Docket Number 50-346

Subject: Confirmatory Action Letter: Response to Request for Additional Information
Related to the Davis-Besse Nuclear Power Station Safety Significance
Assessment

Responses to Request for Additional Information Concerning the FENOC "Probabilistic Safety Assessment" for the Void in the RPV Head at Davis-Besse

Figure 1
 Thickness Measurements
 Plan View from Top of Head

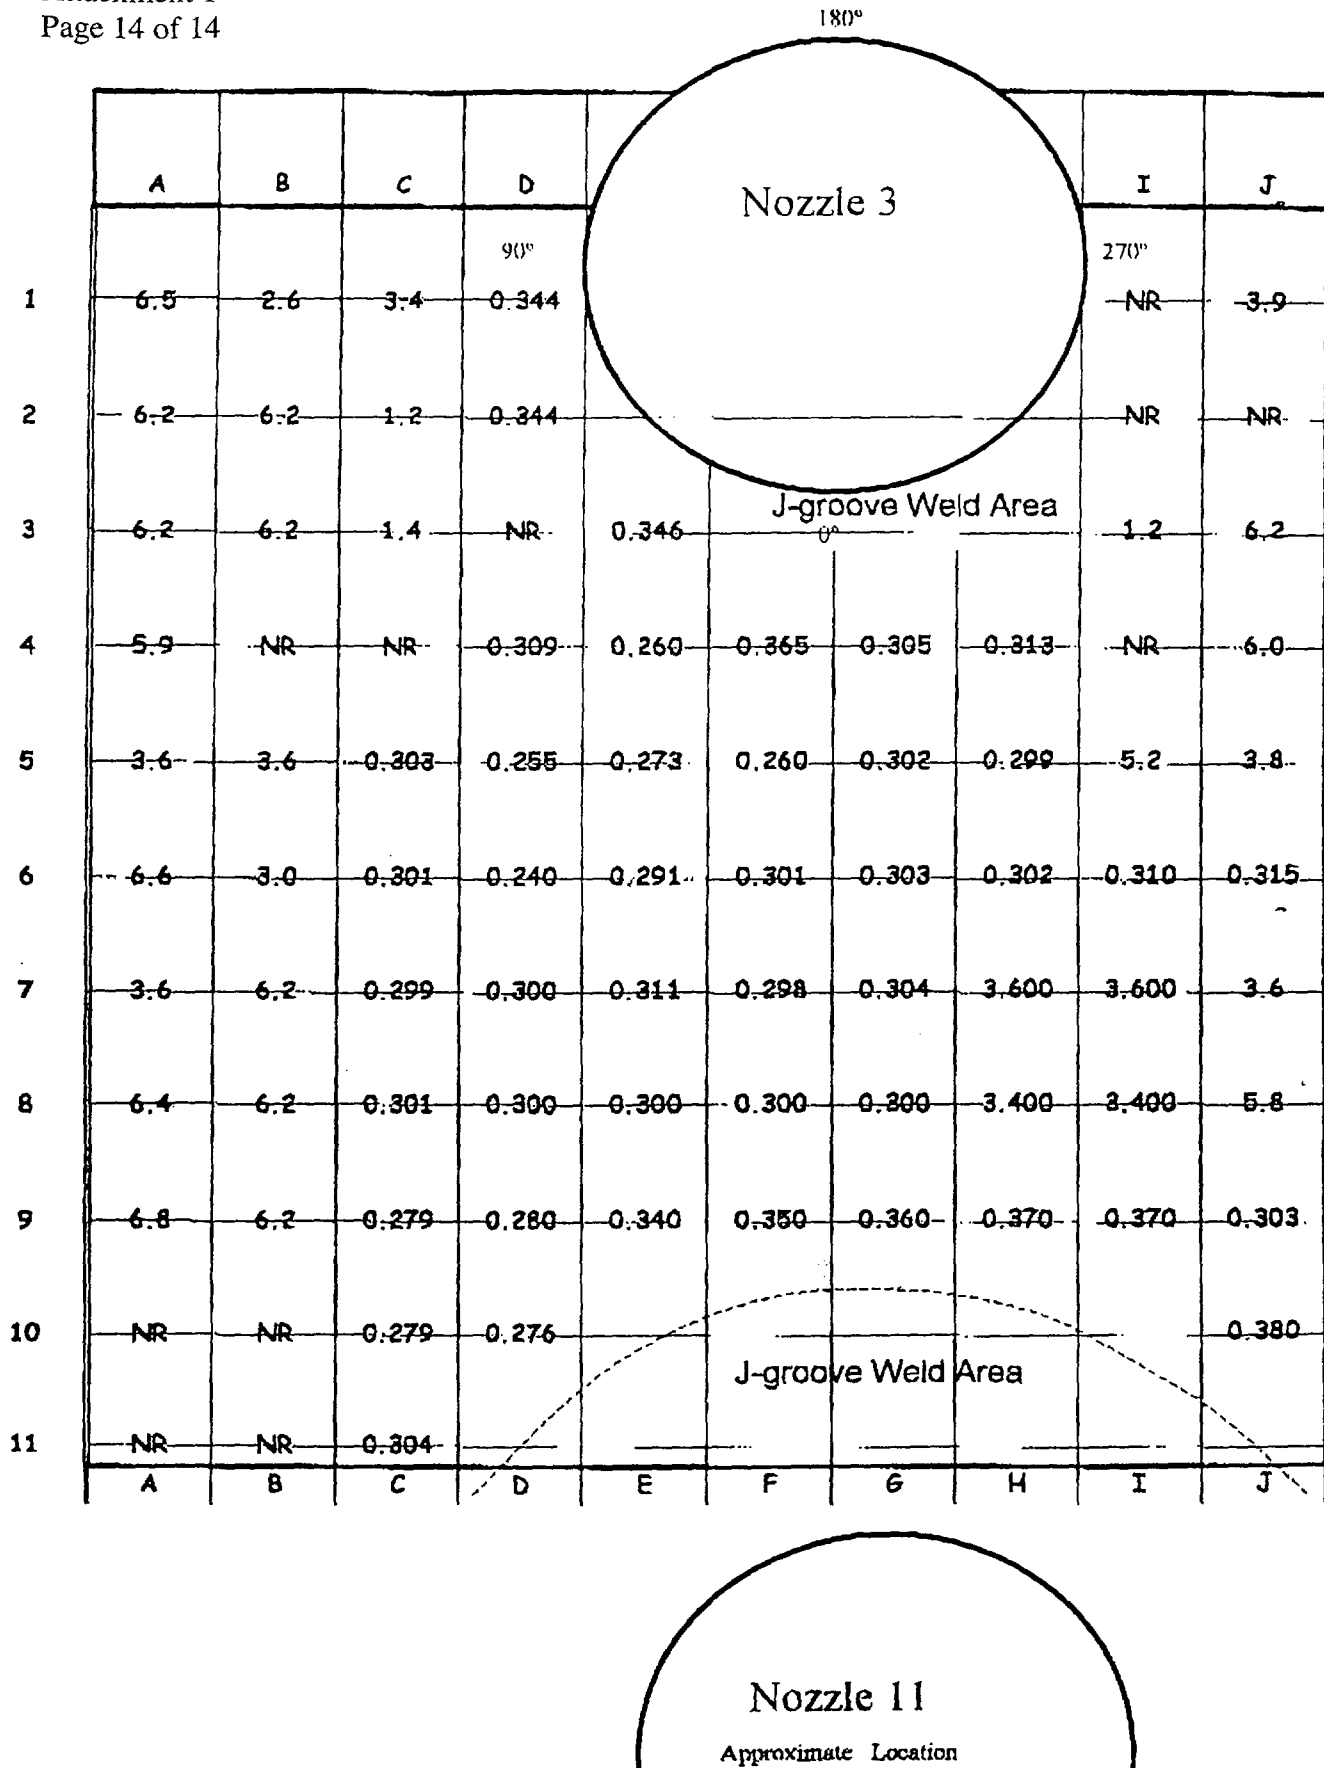
All UT measurements that show clad thickness on the RPV head, including the head location coordinates for each of the measurements.

Refer to Figure 1, which is a map of the UT measurements taken after discovery of the degraded condition.
